Update on EPoC Upstream Pilot Proposal

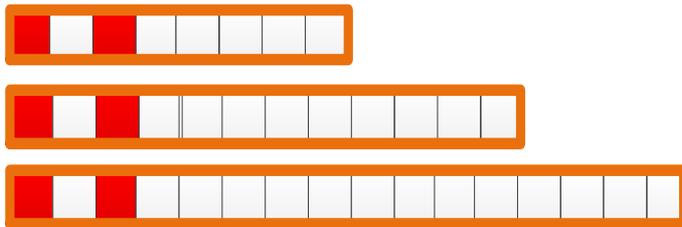
- Word more clearly. Minimum occupied? What are frame boundaries? Between the exclusion band and the frame boundary? AK> See corrections above and below – do they answer the questions?

- At least eight RBs are required for a single grant
- Exclusions
 - A minimum of eight contiguous **used** subcarriers are required between exclusion bands and between exclusions **and the first or the last subcarriers of the OFDMA frame boundaries is eight subcarriers**

- RBs must not be allocated to subcarriers between exclusions that are less than 8 subcarriers to the subcarriers between exclusions If the gap in frequency between these exclusion bands is less than 8 subcarriers wide ~~than eight RBs are not allocated~~

- RBs must not be allocated to subcarriers between an exclusion band and the first subcarrier of the OFDMA spectrum if there are less than 8 subcarriers between them

- RBs must not be allocated to subcarriers between an exclusion band and the last subcarrier of the OFDMA spectrum if there are less than 8 subcarriers between them

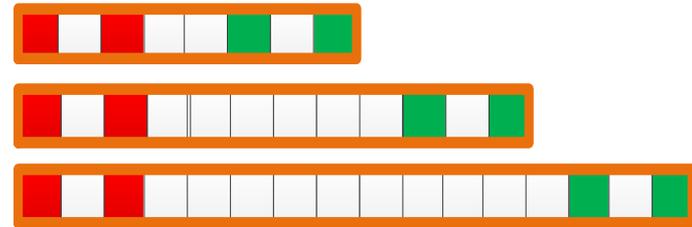
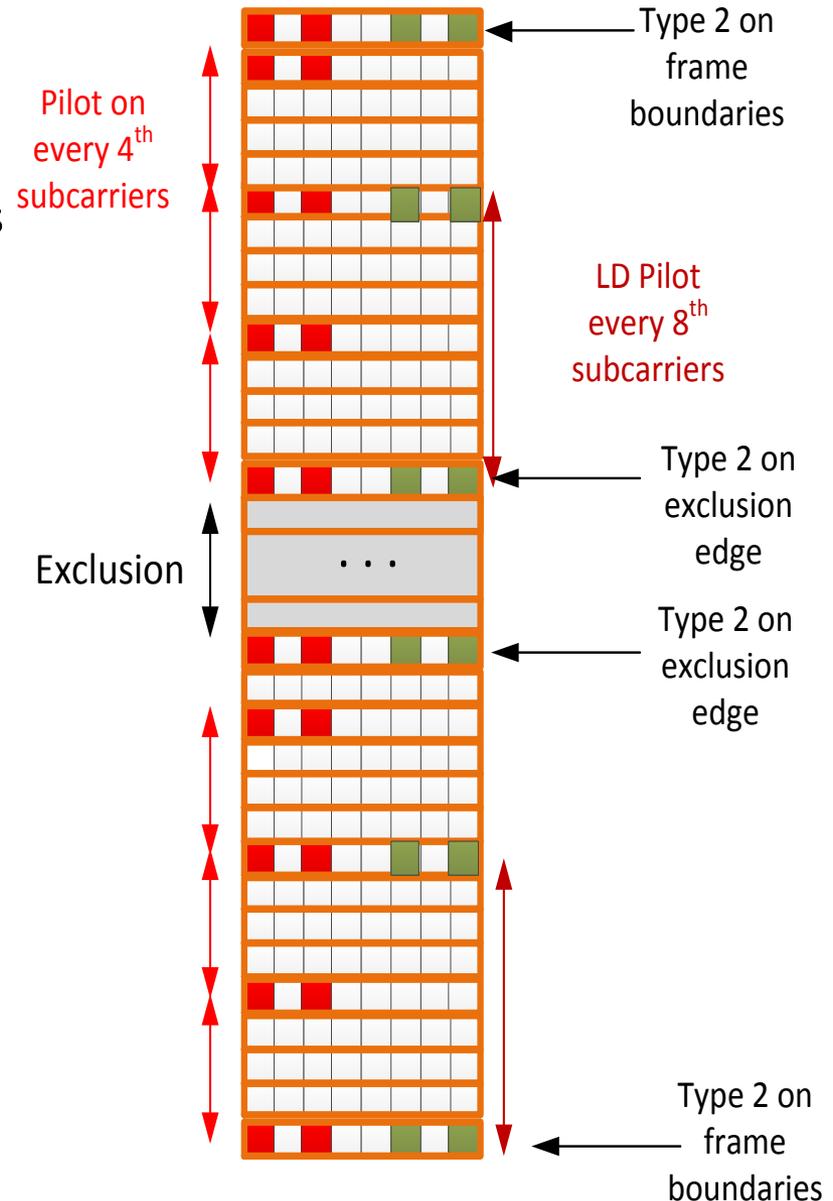
How low density is LD? 1, 2 bits less? State clearly.

- LD density is four bits lower than data density or QPSK, the largest of the two.

Pilot Rules – Examples (2)

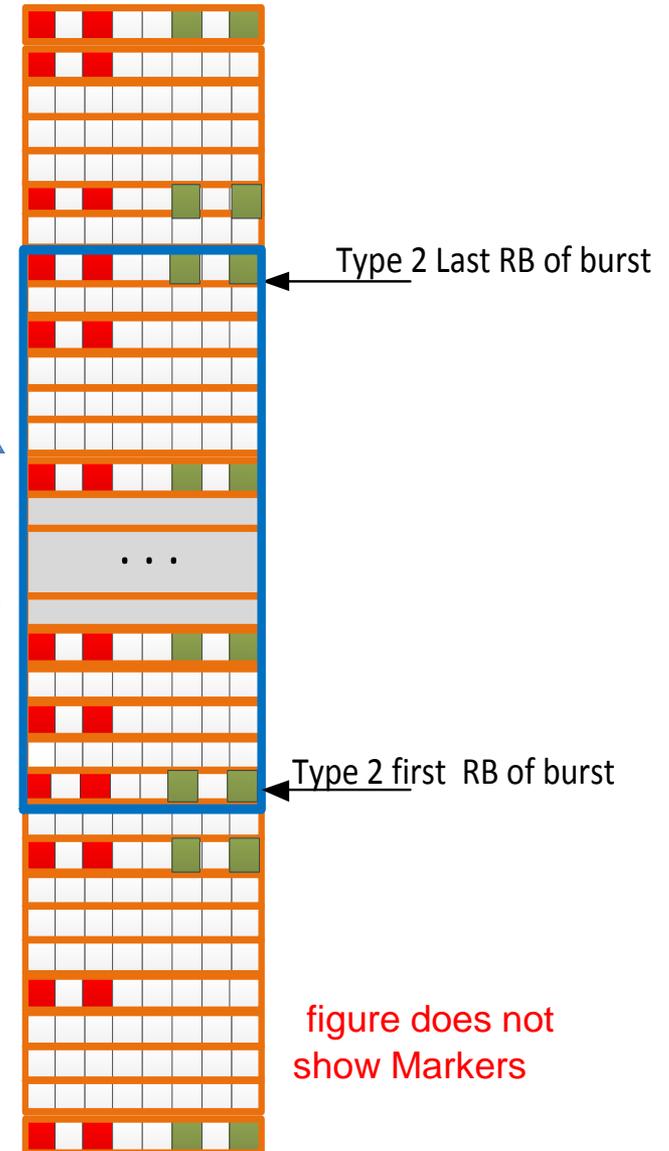
- A transmission burst starts and ends with a Type 2 RB
- These pilots are added over the fixed pilot pattern
- When a start or end “lands” on a Type 1, does it then become a Type 2? How do markers align? and with LD use?

- Why do start/stop pilots necessary? Make part of marker definition (floating) and not part of pilot definition (fixed)?

AK> There is a proposal on how BMs are mapped. See three added slides from Leo’s presentation in Norfolk

AK> You may consider these pilots as part of the BMs. See contribution on the BMs structure and how it is combined with the pilots
